AGENDA
CITY OF CREVE COEUR
BOARD OF ADJUSTMENT
CITY COUNCIL CHAMBER
AUGUST 17, 2023
4:00 PM

- 2. Application #23-7: Variance Requests For The Property At 7 Sherwyn Lane to Encroach 15 feet into the 50 foot Front Yard Setback, 5 feet into the 15 Foot Side Yard Setback as Required by Section 405.250 and to Add 2,230.7 Square Feet of Additional Impervious Area into the Stream Bank Buffers as Regulated by Section 430.050 in Order to Expand the Footprint of the Existing House**

#23-07: VARIANCE REQUEST FOR THE PROPERTY AT 7 SHERWYN LANE TO ADD 1,309 SQUARE FEET OF IMPERVIOUS AREA AND DISTURB 2,061 SQUARE FEET IN THE NO DISTURBANCE BUFFER AND ADD 911 SQUARE FEET OF IMPERVIOUS AREA AND DISTURB 1,593 SQUARE FEET IN THE UNDISTURBED STREAM BUFFER IN ORDER TO ADD ADDITIONAL FIRST FLOOR LIVING SPACE TO THE HOME.

Figure 3: Site Plan that shows proposed conditions. The no disturbance buffer is marked with a red line. The no impervious buffer is marked with an orange line.

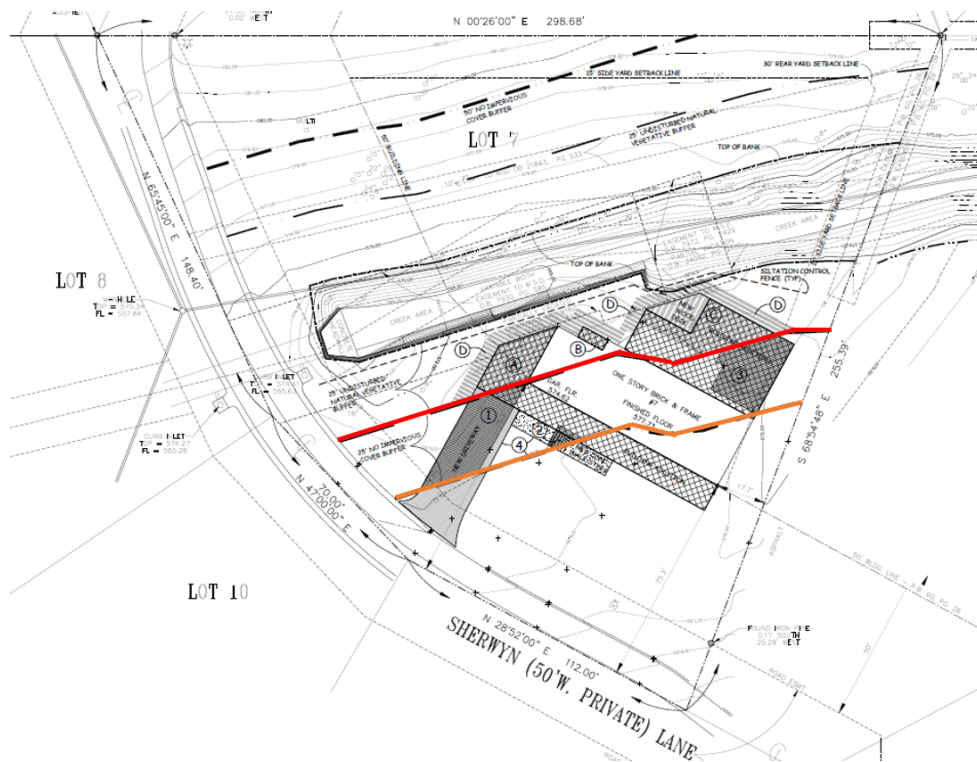
To calculate the amount of mitigation the site would provide, the plan set uses 2,170 square feet as the area of new imperviousness in the buffer zone. Tables on the plan set page 3 of 4, however, appear to show that 2,220.7 square feet of impervious area will be added to the buffer. Using the values assumed in the plan's calculations, 2,170 square feet of impervious area was multiplied by 1.14 inches of rain. The 1.14 inches of rain is the depth used in The 2018 *Metropolitan St. Louis Sewer District Rules and Regulations and Engineering Design Requirements for Sanitary Sewer and Stormwater Drainage Facilities* design guidance for sizing water quality best management practices. Using this equation and values, the plan is showing that 206 cubic feet are intended to be detained.

To satisfy both Chapters 425 and 430, the site proposes the installation of a 4-foot by 12-foot by 12-foot dry well. Assuming 40% void space for the rock area and about 6.3 cubic feet for the volume of the empty Flow Well, the dry well system will provide about 234 cubic feet of detention. The site is providing about 85 cubic feet less detention than is required.

The reviewer from Intuition & Logic suggests that a variance might be more likely to be considered for those areas of the proposed work adjacent to the retaining wall than for areas adjacent to undisturbed buffer areas. On plan sheet 3 of 4, existing conditions areas A and B are adjacent to the retaining wall (approximately two inches of the wall extend above the grade of the adjunct buffer). The building

Figure 5: Site Plan that shows the location of the proposed dry well, outfall pipe, and discharge point in green. The no disturbance buffer is marked with a red line. The no impervious buffer is marked with an orange line.

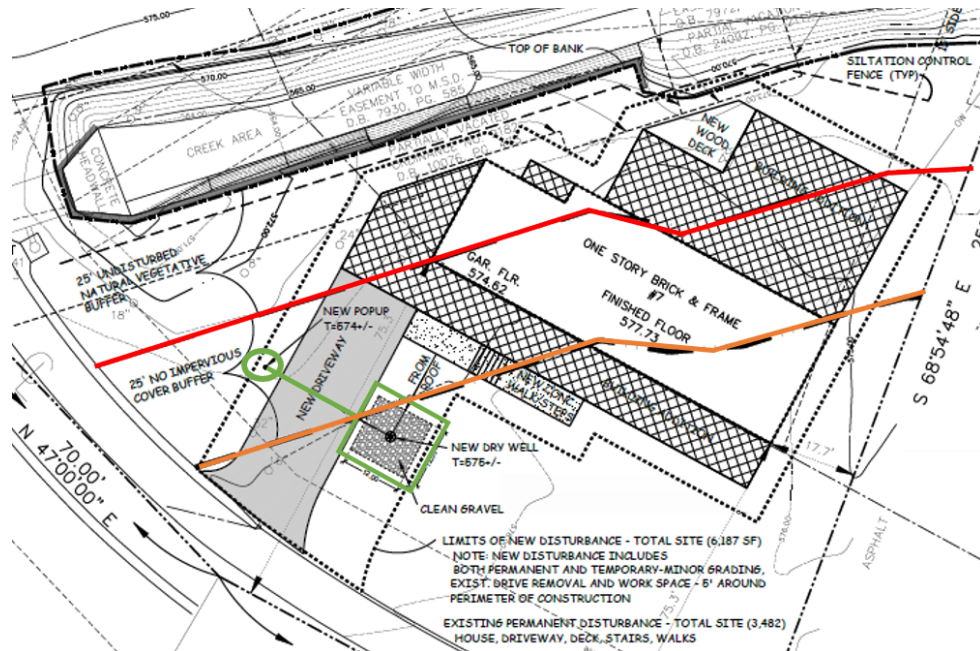
The plan set shows that the dry well will discharge in approximately the middle of the no impervious buffer zone (please see Figure 5 below). The water directed to the BMP from the new impervious area that is not detained in the rocks' void space and discharges from the pipe will not have the full benefit of the stream buffer before entering the creek. If the pipe would discharge into one of the BMP options MSD considers well suited for water quality applications, then it would seem more likely that the variance would be at least as productive of natural resources and the environment.

An important requirement of the plan is to show that the proposed mitigation provides at least as much water quality benefit as the existing stream buffer. Installing BMPs that filter runoff or provide the opportunity for evaporation or evapotranspiration would have perhaps been better substitutes for the loss of buffer area. The City would have preferred to see one of the BMPs in MSD's list of urban water quality BMPs. The reviewer from Intuition & Logic also comments that a dry well is a typical methodology to offset volumetric (quantity) increases and that the dry well does not provide the same water quality as sheet flow to the stream buffer due to the evapotranspiration and phytoremediation provided by the plants.

The reviewer from Intuition & Logic went further and noted that while the east side of the lot has space constraints, the west side of the lot does not have improvements and could have provided opportunities for stream buffer mitigation such as vegetative strips. The reviewer added that Jefferson County has a similar stream buffer ordinance and planting enhancements are a typical mitigation method provided for variance requests.

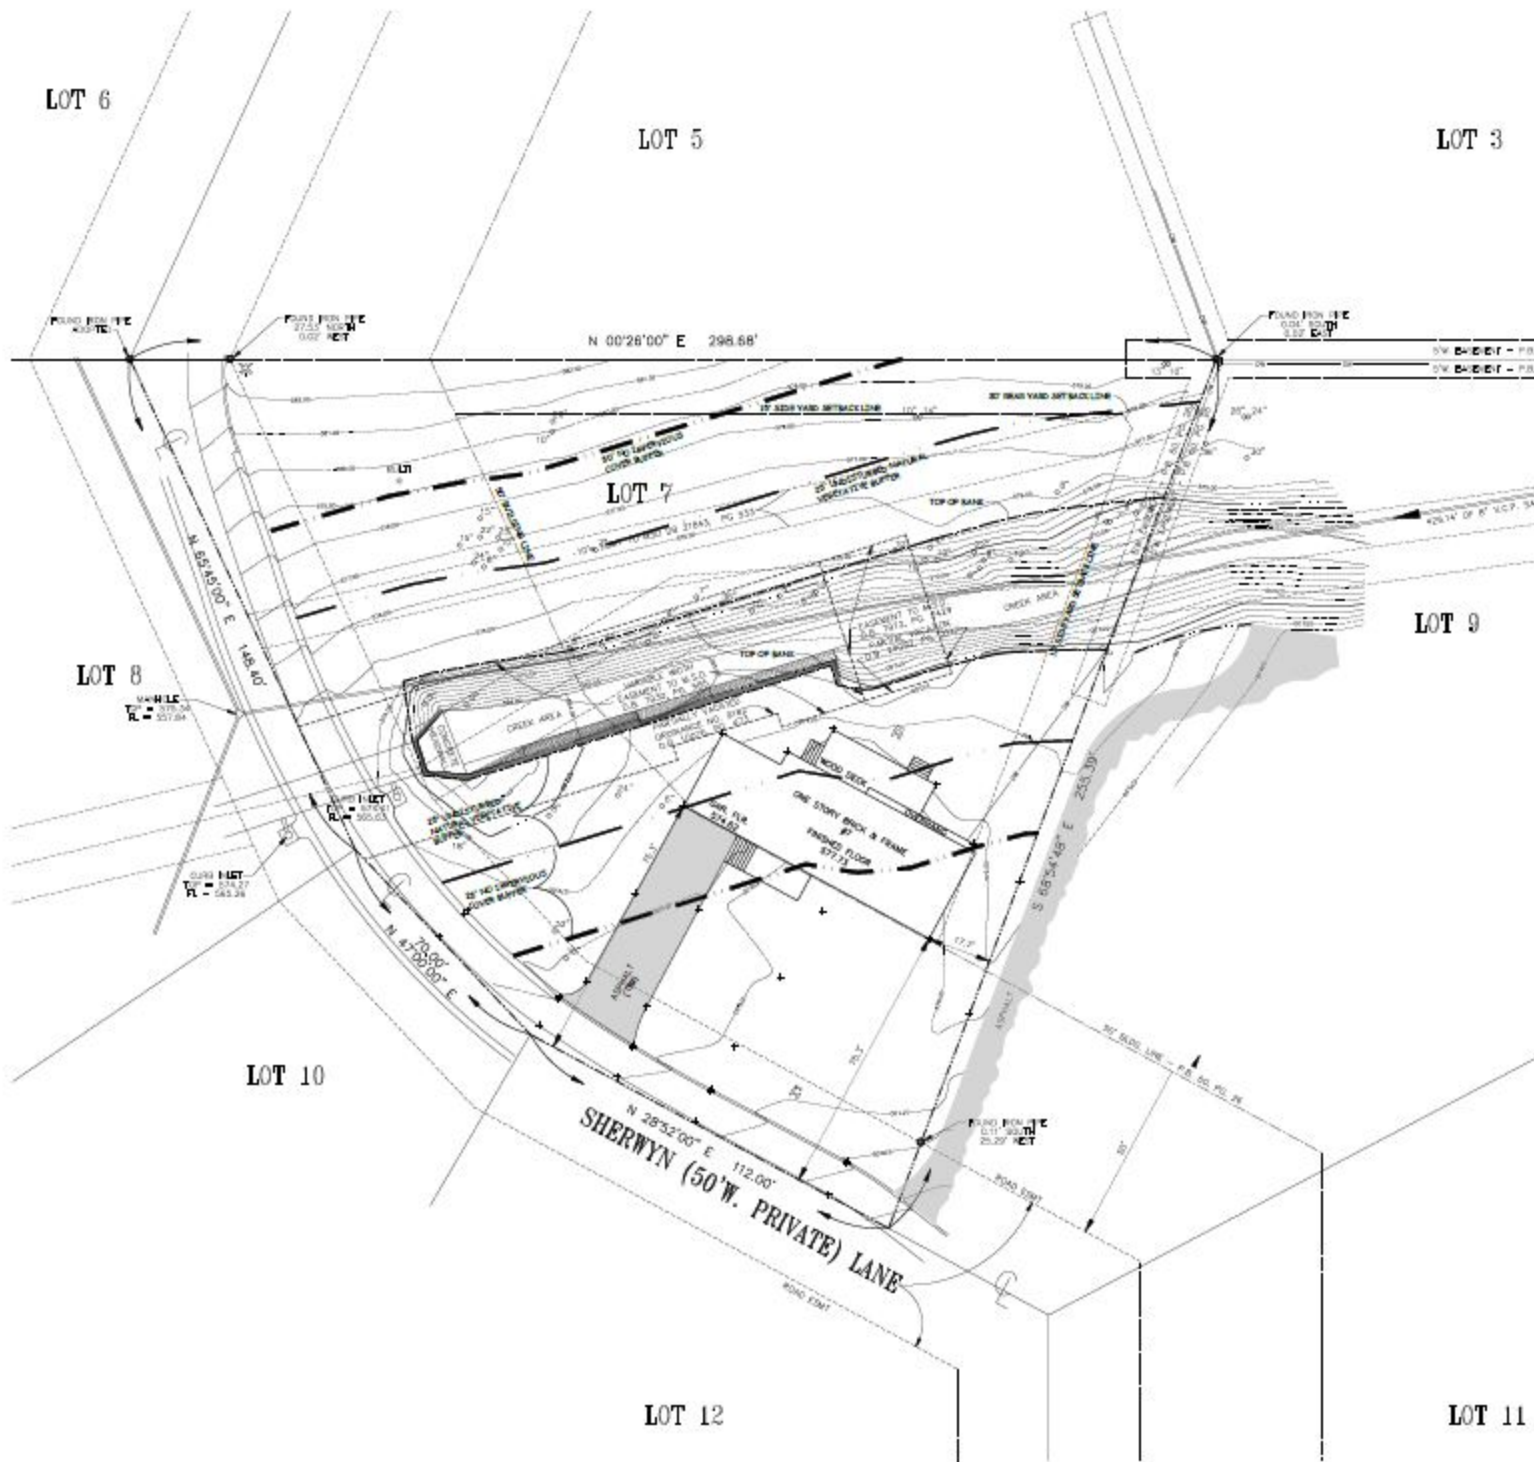
- 1. Please verify that the calculations for the impervious coverage within the two buffer zones on sheet 3 of 4 is correct. Proposed and existing impervious coverage totals in the buffer zone are different than disturbance area total in the buffer zone. Please provide separate, clear tables addressing both the impervious coverage within the two buffer zones and the total disturbance within the two buffer zones.**

- 2. The City's Section 430.050.B.3.h. has not been met. Please refer to MSD Rules and Regulations and Engineering Design Requirements for Sanitary Sewer and Stormwater Drainage Facilities, February 1, 2018 Sections 4.060.02 and 4.060.05.**

The Stream Buffer information is modified to enhance clarity. Also, a Summary Table has been added per the City's request (Please see sheet 3).

Runoff calculation is corrected (Please see sheet 4).
